Florida Department of Transportation

STRUCTURES DESIGN BULLETIN 16-05

SUBJECT: Stirrups in Reinforced or Prestressed Concrete Beam Members

Figure 4.1.4-1 Shear Reinforcement Layout in Beam Members

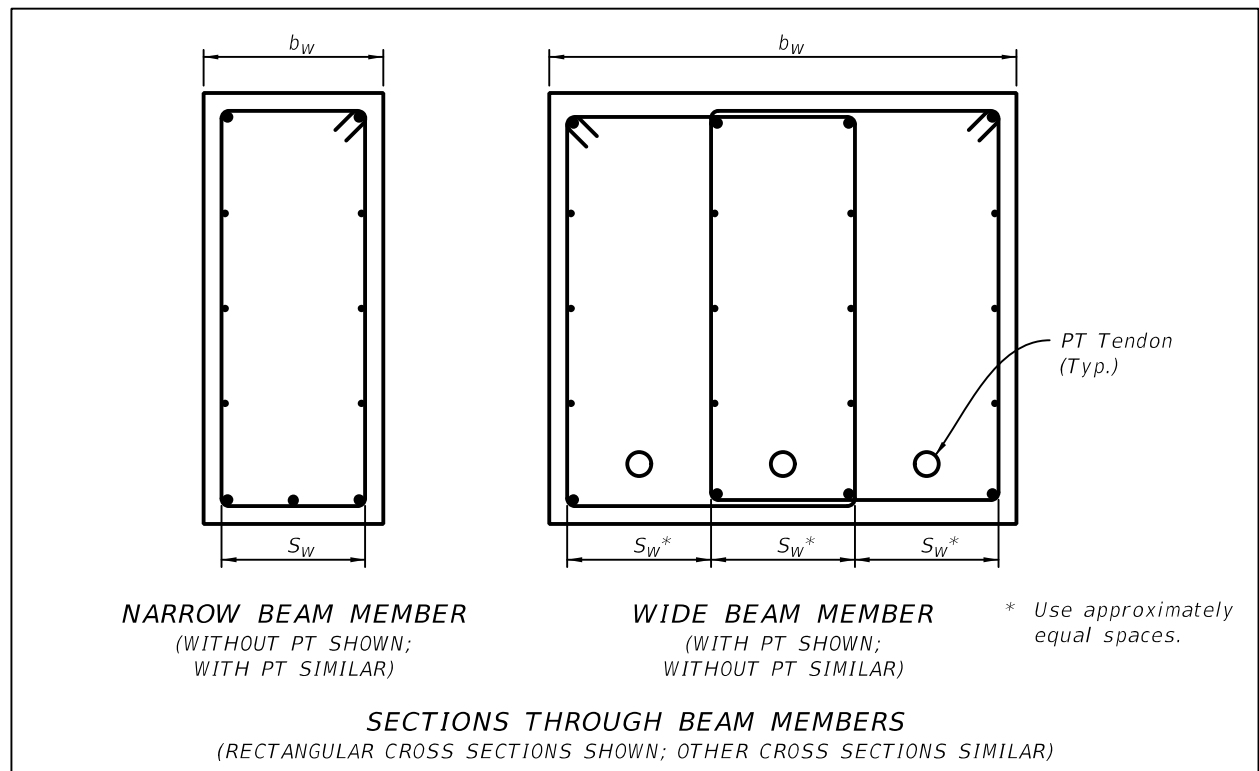
C. Use the following methodology to determine the transverse spacings of shear reinforcement in beam members:

Nominal Shear Stress Range	Maximum Transverse Spacing of Stirrup Legs S_w as shown in Figure 4.1.4-1
$v_n \leq 0.08\sqrt{f'c}$	$S_w \leq 42"$
$0.08\sqrt{f'c} < v_n \leq 0.16\sqrt{f'c}$	$S_w \leq d_v$ or 24", whichever is less
$v_n > 0.16\sqrt{f'c}$	$S_w \leq 0.5d_v$ or 12", whichever is less
